**CITY OF EL PASO, TEXAS  
AGENDA ITEM  
DEPARTMENT HEAD'S SUMMARY FORM**

# CITY OF EL PASO CONSTRUCTION CHANGE ORDER

CONSTRUCTION CHANGE ORDER NO.: 7      DATE: August 15, 2011       SCOPE CHANGE  
 PROJECT: International Bridges - Stanton Toll Facility and Paso Del Norte      SOLICITATION NO. 2010-170       CONSTRUCTION CHANGE

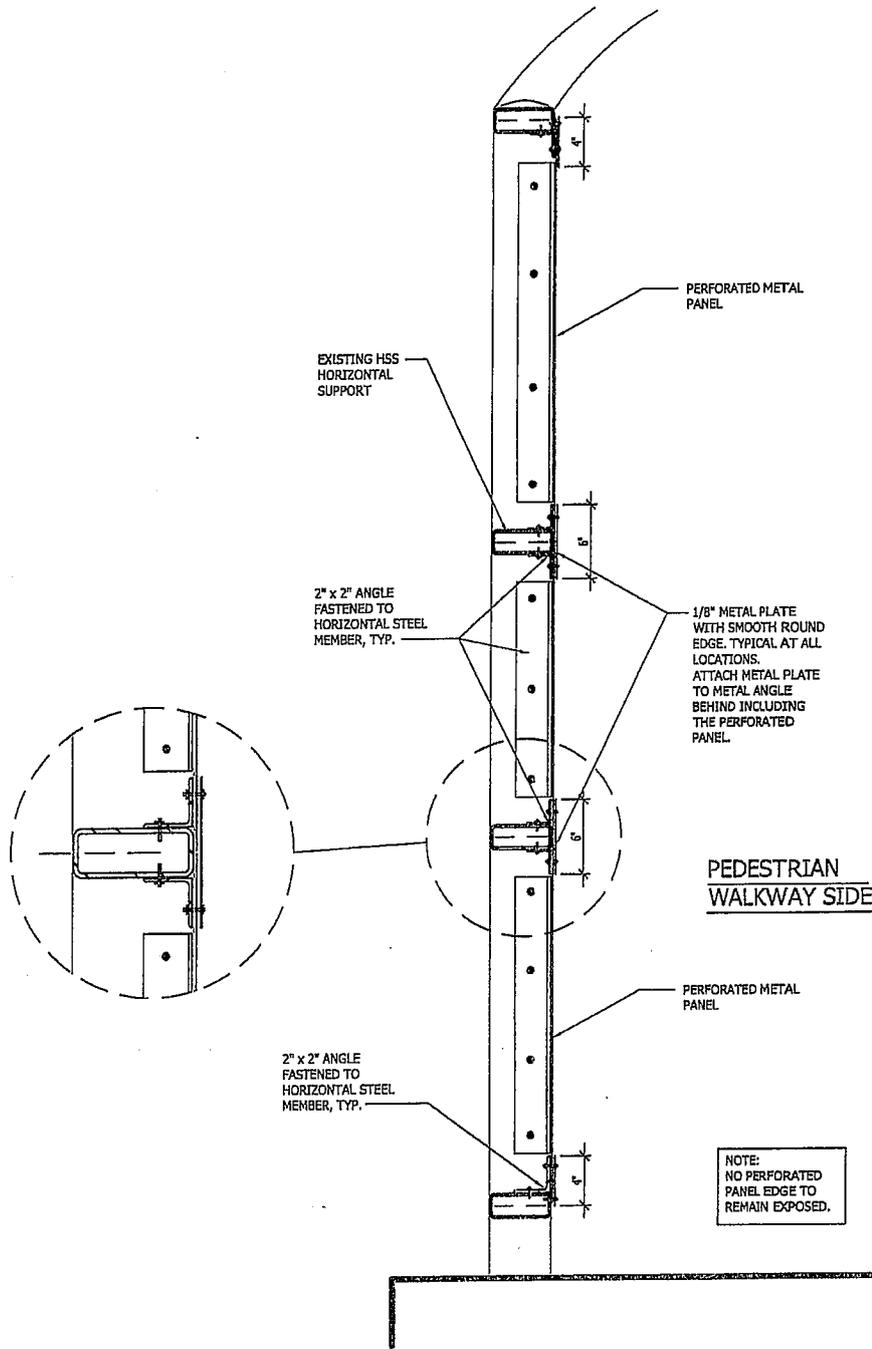
**Notes**  
Provide a price to install additional steel angles and plates to attach the Stainless Steel Perforated Metal panels in the bridge pedestrian canopy as shown in the attached SKA drawings and as approved in the mockup during the 5/31/2011 visit to El Paso Machine & Steel shop.
